DE HAVILLAND AIRCRAFT of CANADA

STANDARDS SHEET

EXTRUDED TEE

CVR41

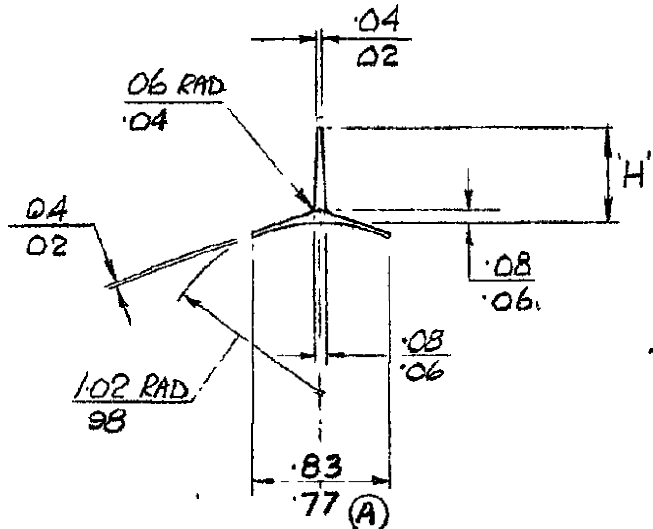
AR 328-C-300
DELETED
MIL SPEC INF
(CLASS TYPE
GRADE, COLOR
ADDED TO -5.

③
① FLAMMABILITY REQUIREMENT
ADDED AS NOTE 1. 30 NOV 78 YR

② -5 ADDED
NITH TABLE
LAWSON 6 JUNE 78 YR

④ AMS-3345 E
AR 334 ADDED
26 JUL 68 SFG
A A ALBERTA
23-R-66
77 WA 20170
E A 22671 - C A 5 E 77

WEIGHT FIG AND
14 FEB 60
⑤ -7 ADDED YR. 27 MAR 85 (G) FAR RULE
NOTE: 2 ADDED
FLAMMABILITY REQUIREMENTS CHANGED
16-9-86 D.C. YR AR

NOTE 1. -3 TO MEET FLAMMABILITY REQUIREMENT ~~DHMS 69.01~~
~~CLASS 'B' METHOD 2.~~ (G) FAR 25.853(b-2) AND 25-5

NOTE 2. -7 BLACK FEL STD 595 37088 TO MEET REQUIREMENTS
OF FAR 25.855(a-1) AMEND 25-51.
(G) FAR 25.853(b-2) AND 25-51 ON A 45° BURN THROUGH TEST ONLY
OF FAR 25.855(a-1) AND 25-51
